TECHNICAL SERVICE BULLETIN**Bulletin No.:** TSB-006**Date:** October 23, 2014**Subject:** PRD Manifold Mount**Models:** Frame Mount Fuel Storage Modules (Equipped w/ Circle Seal PRDs)**Background**

All FSMs that utilize 80" and 90" cylinders have Pressure Relief Device (PRD) manifolds. The PRD manifolds are connected to a live port on the tank valve and are designed to safely vent the cylinder under certain conditions.

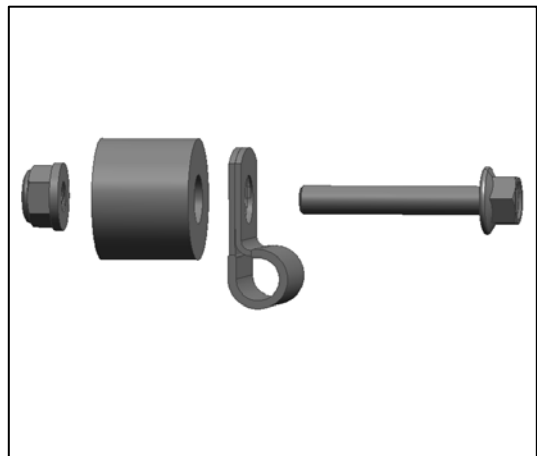
In some cases, the vibration mount which holds the PRD manifold assembly in place may fail and allow the PRD line to droop. If the PRD manifold is permitted to droop and is not corrected, then PRD valve damage or fuel leakage may occur.

The vibration mount is designed to have threaded ends which are torqued into position such that the PRD line assembly does not move once installed. Certain FSMs have experienced vibration mounts coming loose or breaking causing the PRD line to droop and cause the PRDs to contact the FSM covers.

Inspect the PRD lines and mounts, if your fuel storage module is equipped with the orange colored PRD manifold mounts (as shown in the picture) they must be replaced. If your fuel storage module has already had updated PRD manifold mounts installed no further action is required.

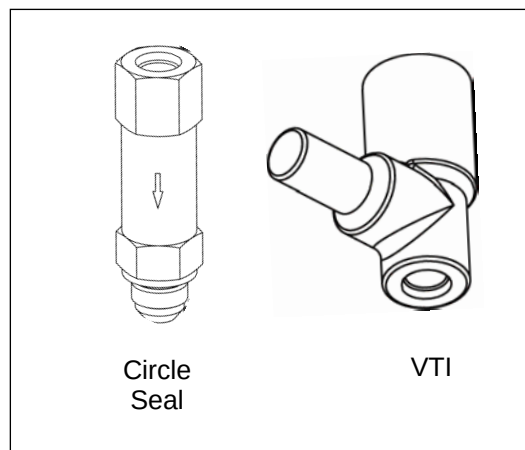
This service procedure only applies to FSMs equipped with circle seal PRD manifold assemblies.

Circle seal PRD manifolds are equipped with 1/2" lines.

The VTI PRD manifolds are equipped with 3/8" lines.

The VTI PRD manifolds should already be equipped with the improved PRD mounts.

PRD Manifold Mount Replacement Procedure

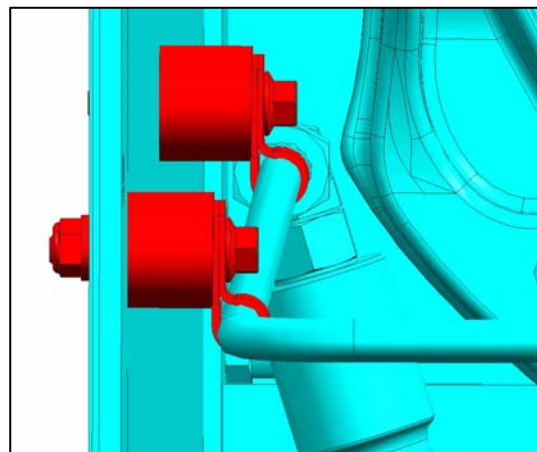
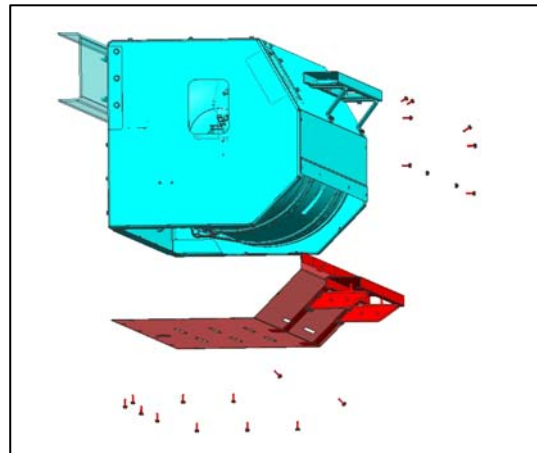
1. Verify the vehicle ignition is OFF.
2. Remove the 7 bolts and 2 nuts from the front cover as shown in the illustration to the right.
3. Remove the lower cover bolts from the FSM.

4. Carefully move the lower lip of the top cover to clear the studs on the lower cover, then remove the lower cover.
5. Inspect the mount hardware, PRD line, and PRDs for wear and/or abrasion damage.

- a. If the fuel storage module is still equipped with orange PRD manifold mounts, then proceed to Step 6 to replace the mounts.
 - b. If either the PRDs and/or manifold assembly have been damaged, then the entire PRD manifold assembly will need to be replaced. Follow the cylinder vent procedure and safety messages as specified in the CNG Cylinder Installation & Maintenance Manual at www.qtwv.com/service.

- c. Once the cylinder has been safely vented, remove the existing 1/2" PRD manifold assembly and install the 3/8" PRD manifold assembly with VTI PRD valves. Proceed to Step 6 when installing the mount hardware.
